Economic Commission for Europe
Inland Transport Committee
World Forum for Harmonization of Vehicle Regulations
Working Party on Lighting and Light-Signalling
Eightieth session

UN Regulations Nos. 37 (Filament lamps), 99 (Gas discharge light sources), 128 (Light emitting diodes light sources) and the Consolidated Resolution on the common specification of light source categories
Proposal for Supplement [8] to the original version of UN Regulation No. 128 (Light emitting diodes light sources)
Corrigendum

Figure 1

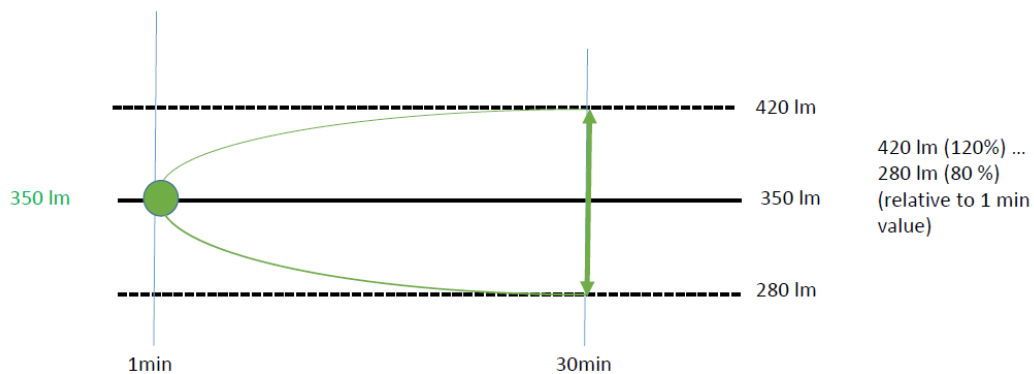
After paragraph 4, *insert* the figure below

Example of allowed luminous flux behaviour of an approved LED light source under UN Regulation No.128, Annex 4, paragraph 1.2.

Green: proposed addition: range after 1 min and 30 min, positive or negative "gradient"
